DOK | 2007 Bridge Inspection Review and Rating | Dec.1st, 2008

Issues in red require immediate attention
Issues in bold black need attention for safety concerns

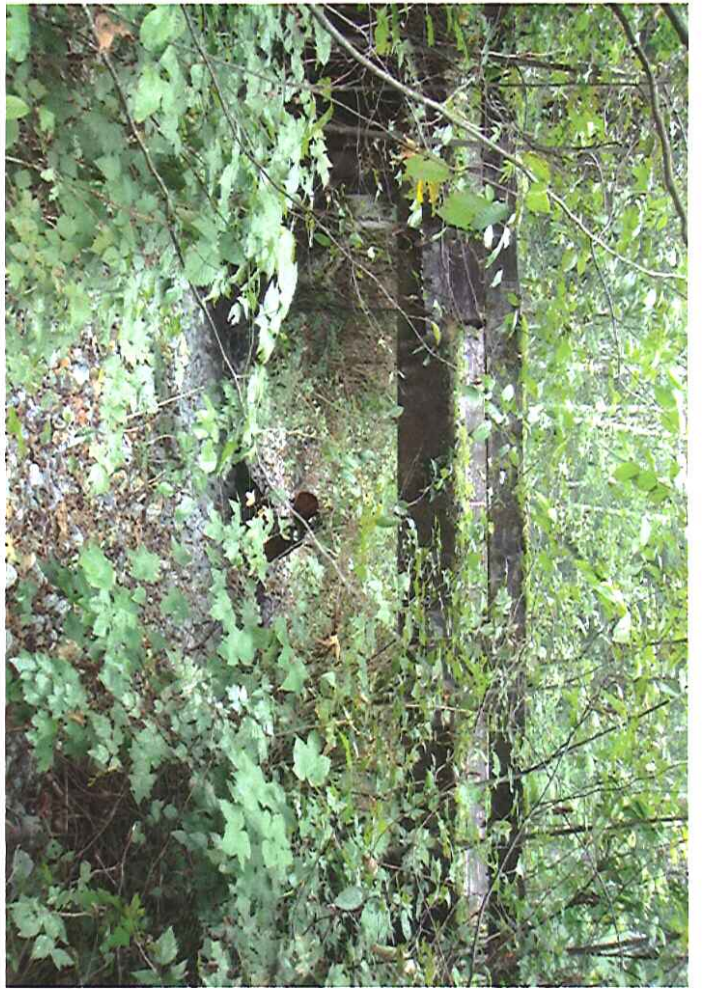
The overall condition of the structure is fair. Consider installing narrow structure signs at approaches.

Retain present load rating of L75 (68 tonnes)

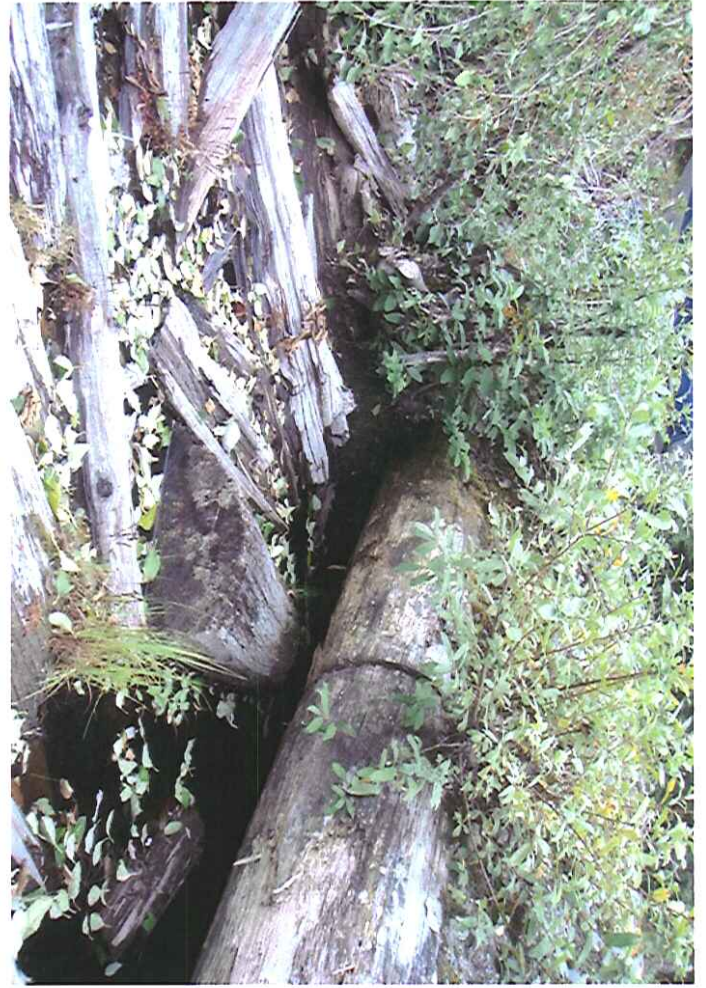
Based on the condition of the upstream stinger the overall condition of this structure is poor.

Recommend downrating to 2 tonnet PV. Missing information to properly rate bridge.
Recommend planning to replace bridge.

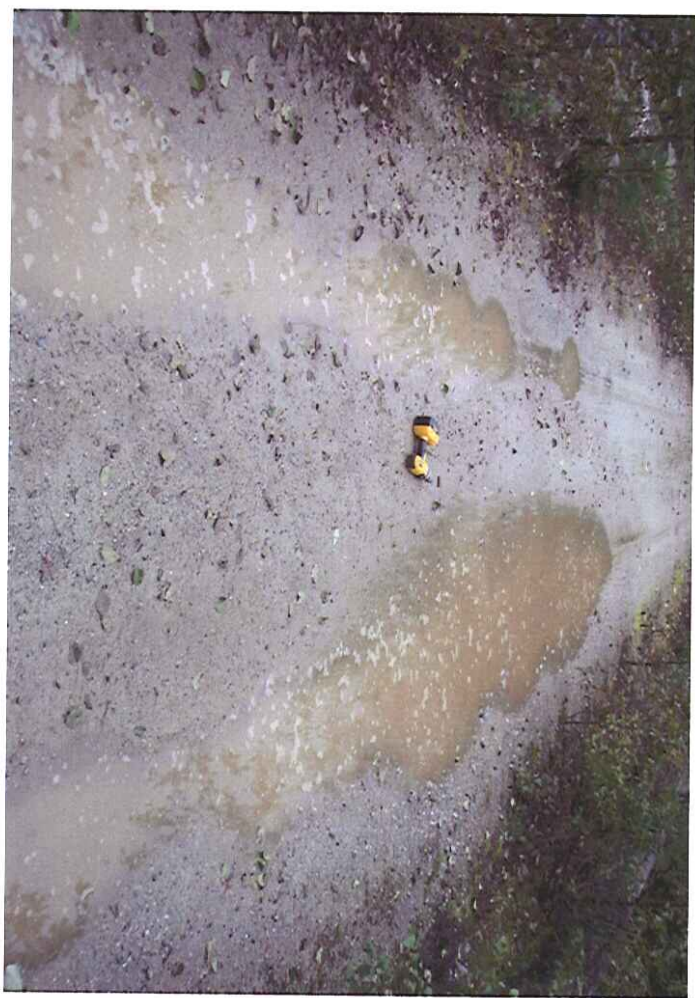
Based on the condition of stringer #4 and the fact that the needle beams are no longer functioning, the overall condition of this structure is poor. We recommend that the structure be replaced in the near future.

Strongly recommend bridge closure, and replacement.
